ACER_SJM31

Monday, May 04, 2009	2009-ECO-006989	B
DATE	CHANGE NO.	REV

TITLE ACER_SJM31_USB Board

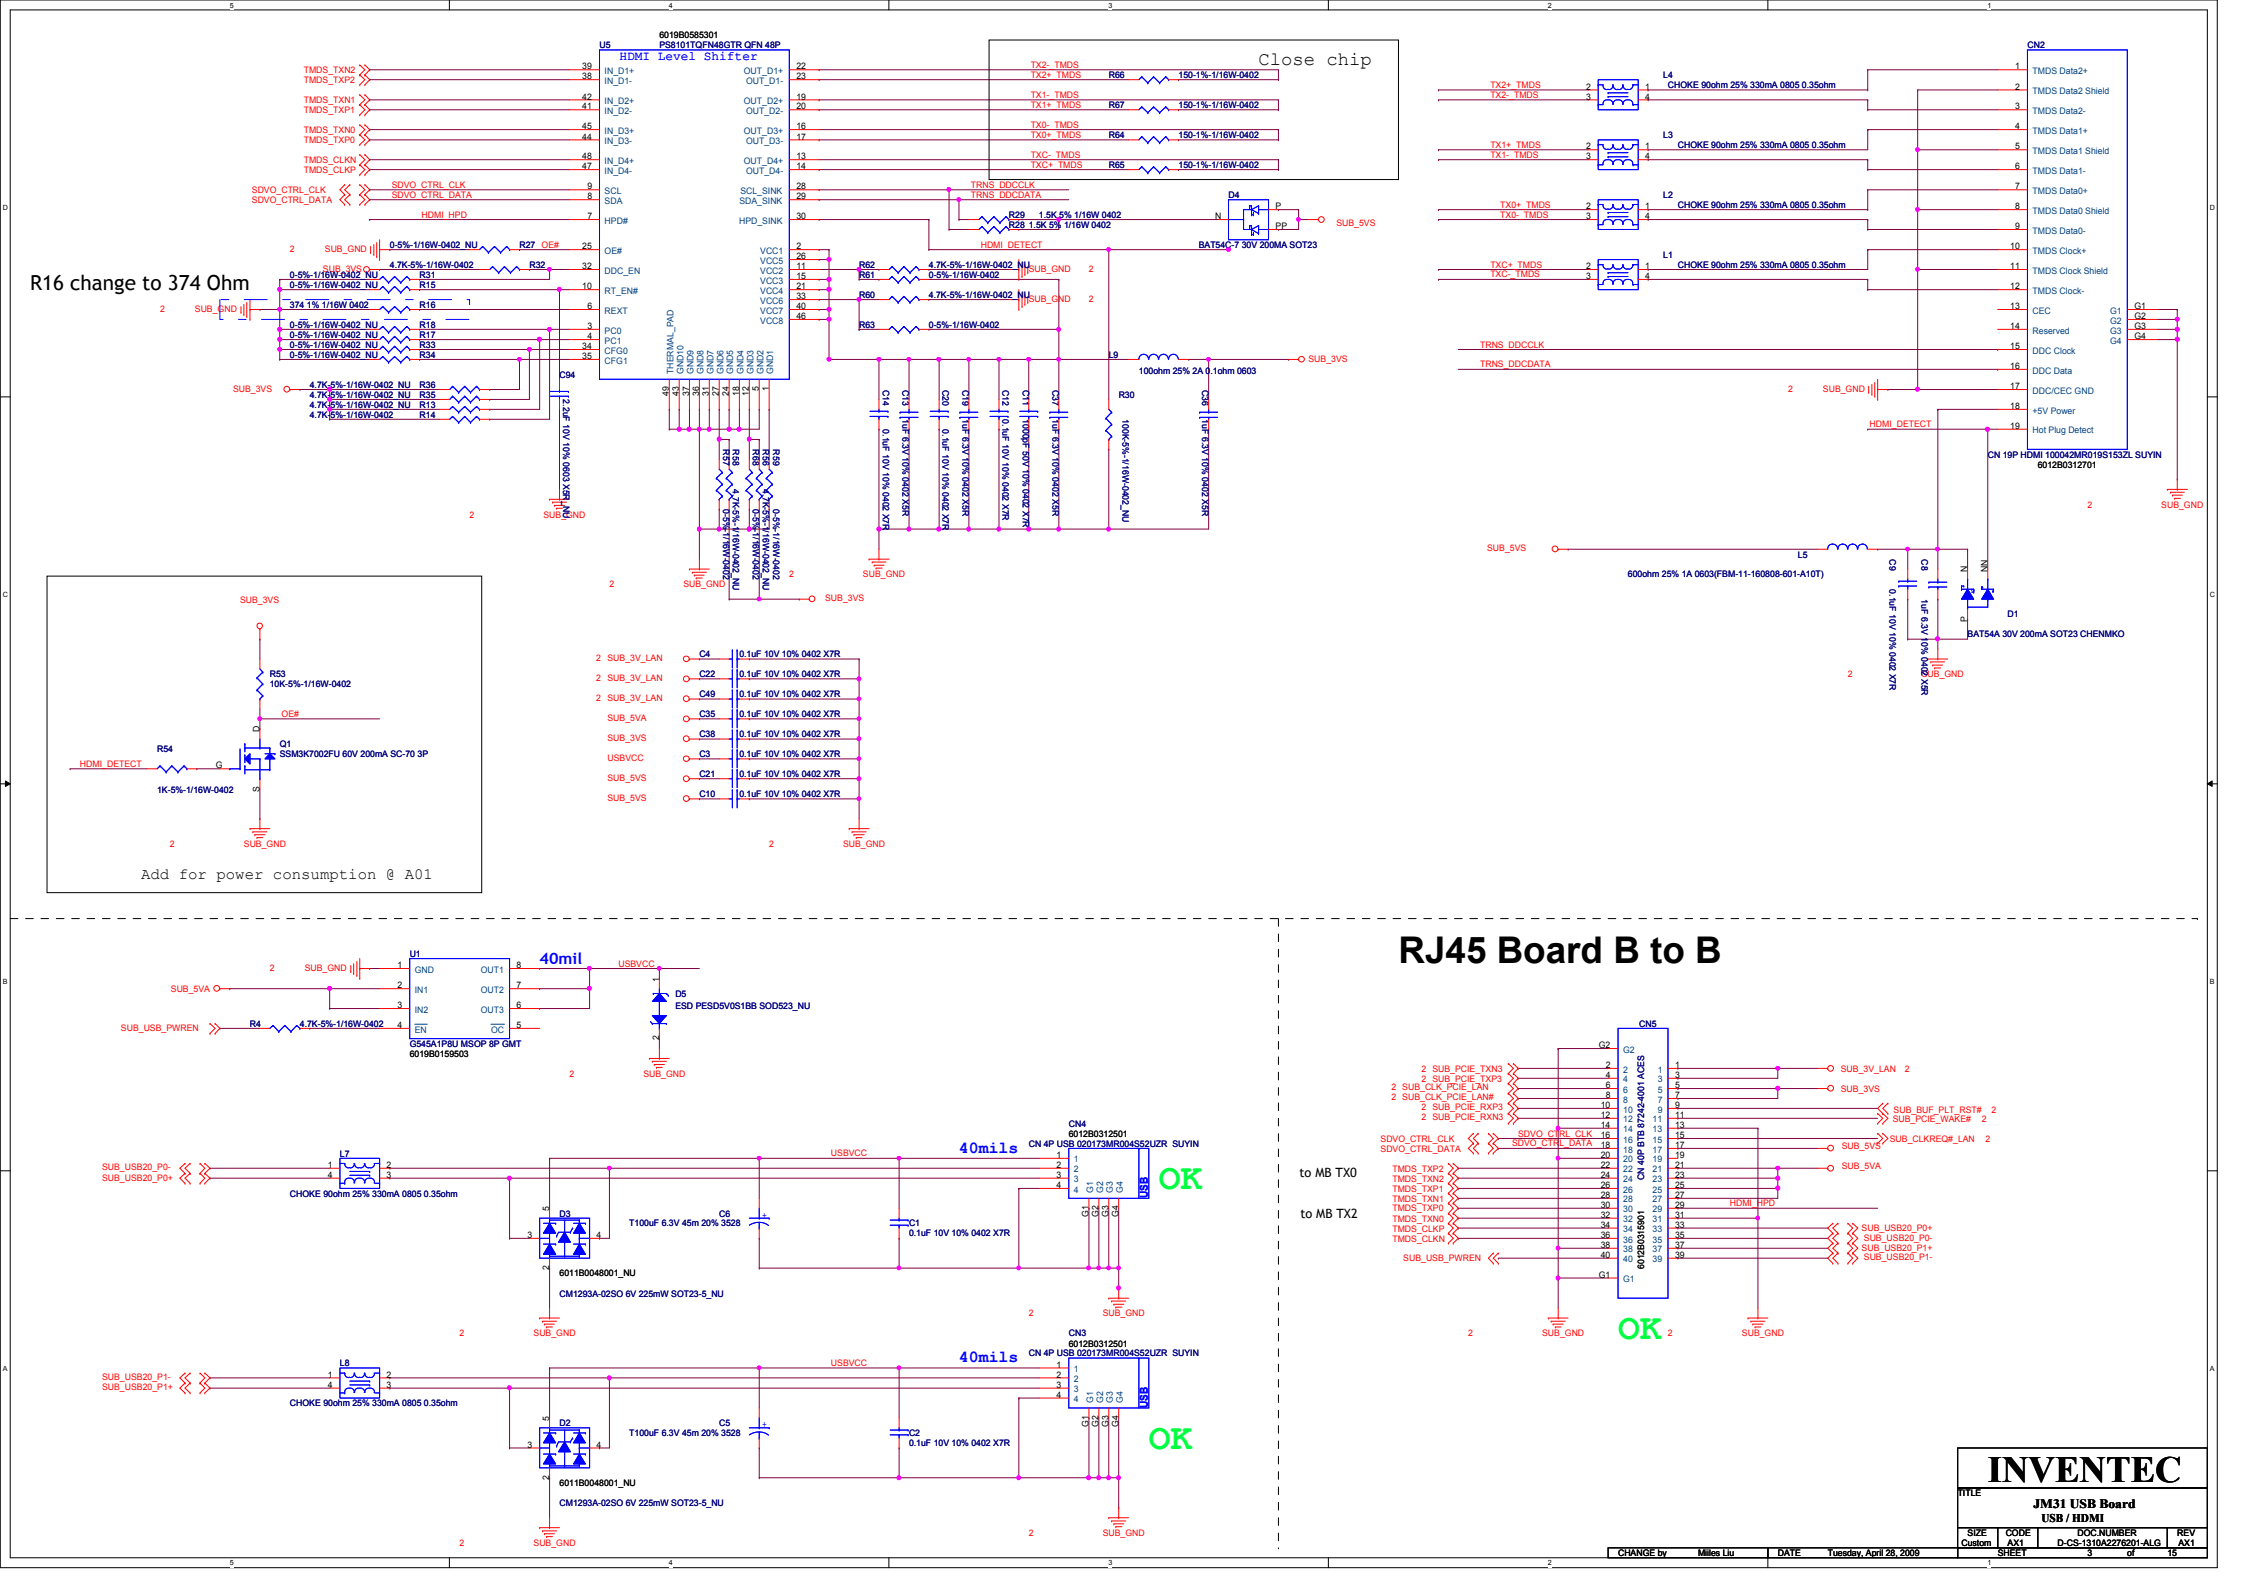
U5
6019B0585301
PS8101TQFN48GTR QFN 48P
HDMI Level Shifter
Close chip
R16 change to 374 Ohm
CN2
CN 19P HDMI 100042MR019S153ZL SUYIN
6012B0312701
Add for power consumption @ A01
RJ45 Board B to B
CN5
CN4
CN3
OK
OK
INVENTEC
JM31 USB Board
USB / HDMI
D-CS-1310A2276201-ALG
Tuesday, April 28, 2009
Miles Liu

4.7pF 50V 0.25% 0402 C0G
LENGTH MAX=0.5''
CP_CRT_VSYNC
R204
75-5%-1/16W-0402
CRT_VSYNC_PORT
Change to 4.7p for VESA
C204
4.7pF 50V 0.25% 0402 C0G
INVENTEC
TITLE
SJM31 VGA Board
CRT & SWITCH
SIZE Custom
CODE CS
DOC.NUMBER D-CS-1310A2759-0-ALG
REV A
CHANGE by Miles Liu
DATE Monday, May 04, 2009

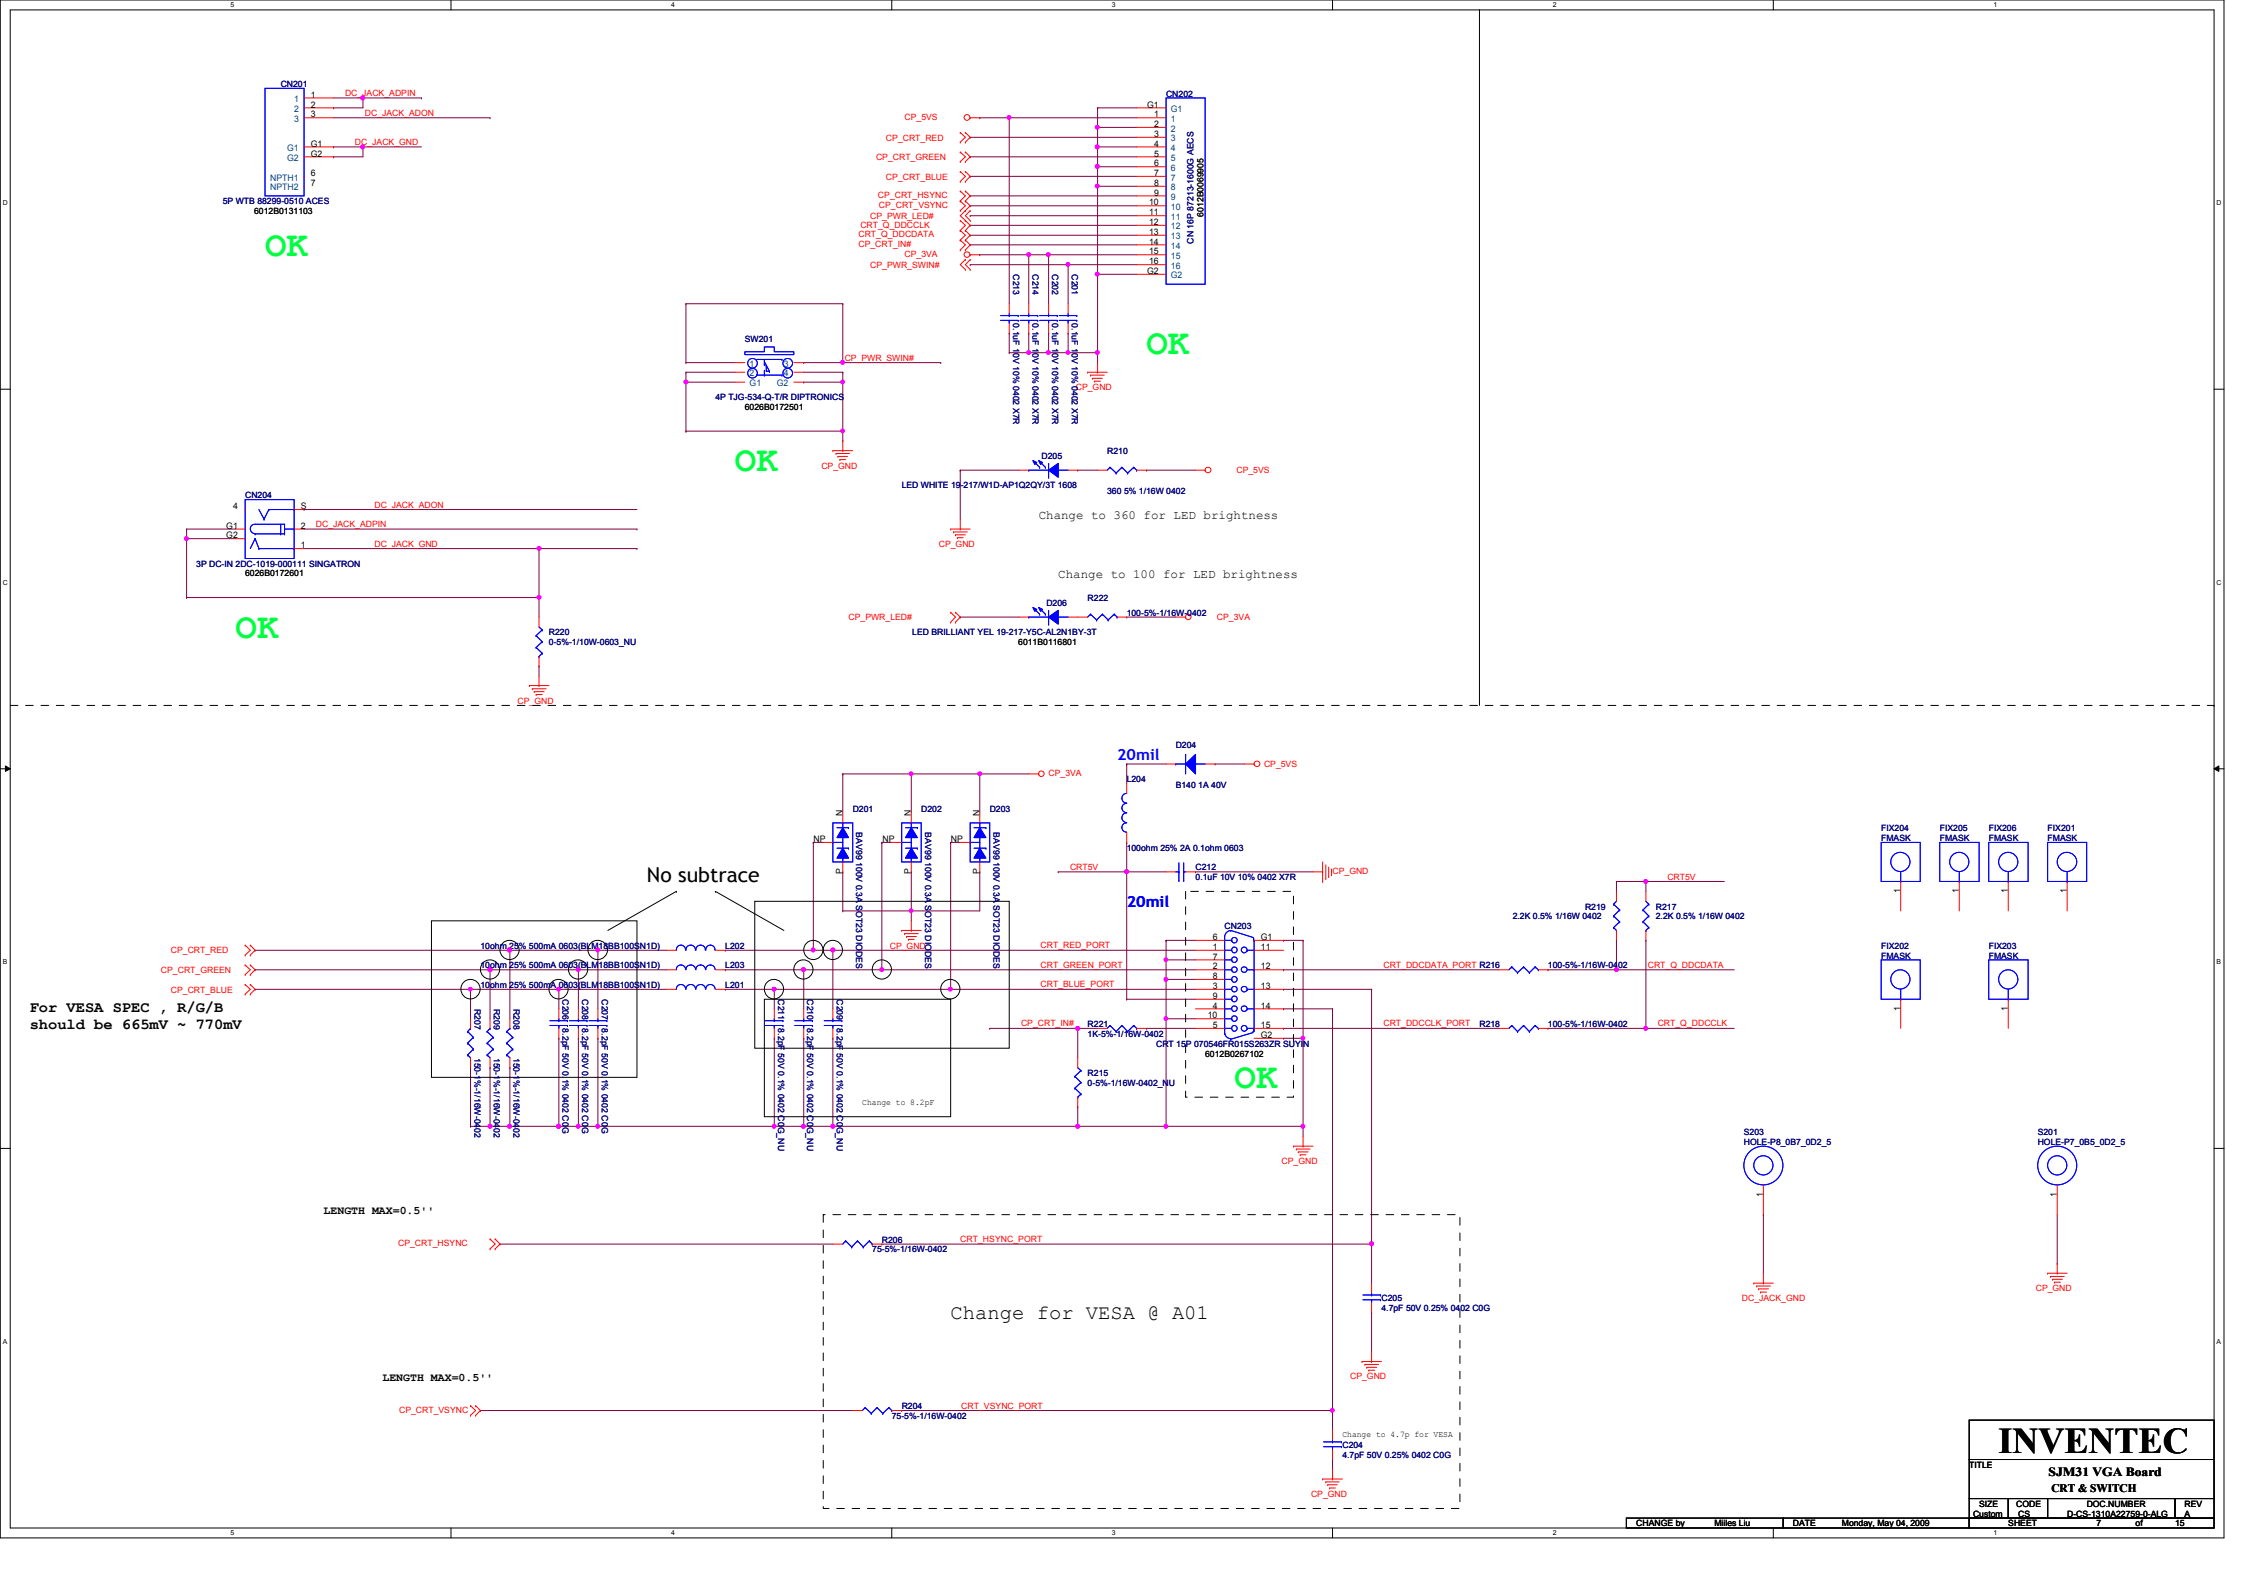
2.2K 0.5% 1/16W 0402
R217
2.2K 0.5% 1/16W 0402
CRT_Q_DDCDATA
CRT_Q_DDCCLK
FIX204 FMASK
FIX205 FMASK
FIX206 FMASK
FIX201 FMASK
FIX202 FMASK
FIX203 FMASK
For VESA SPEC , R/G/B
should be 665mV ~ 770mV
R207 150-1%-1/16W-0402
R209 150-1%-1/16W-0402
R208 150-1%-1/16W-0402
C208 8.2pF 50V 0.1% 0402 C0G
C209 8.2pF 50V 0.1% 0402 C0G
C207 8.2pF 50V 0.1% 0402 C0G
C211 8.2pF 50V 0.1% 0402 C0G_NU
C210 8.2pF 50V 0.1% 0402 C0G_NU
C206 8.2pF 50V 0.1% 0402 C0G_NU
Change to 8.2pF
S203
HOLE-P8_0B7_0D2_5
DC_JACK_GND
S201
HOLE-P7_0B5_0D2_5
CP_GND
LENGTH MAX=0.5''
CP_CRT_HSYNC
R206
75-5%-1/16W-0402
CRT_HSYNC_PORT
Change for VESA @ A01
C205

INVENTEC			
TITLE: SJM31 Cardreader Board CR_RTS5159E			
SIZE: C	CODE: AX1	DOC NUMBER: D-CS-1310A2270301-ALG	REV: AX1
		SHEET 9 of 15

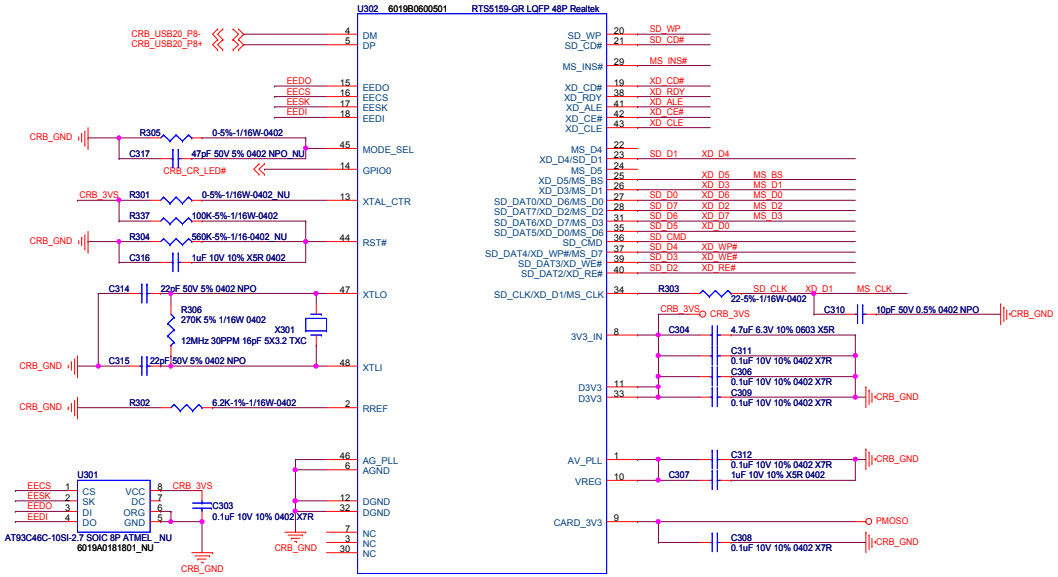
已反過PIN

TITLE: SJM31 GP Button Board
GP Button

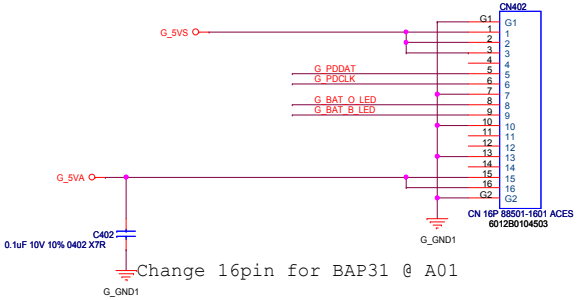
Change 16pin for BAP31 @ A01

TITLE: JM31 SW sensor Board
SW sensor

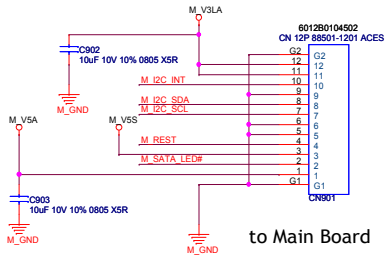
已反過PIN
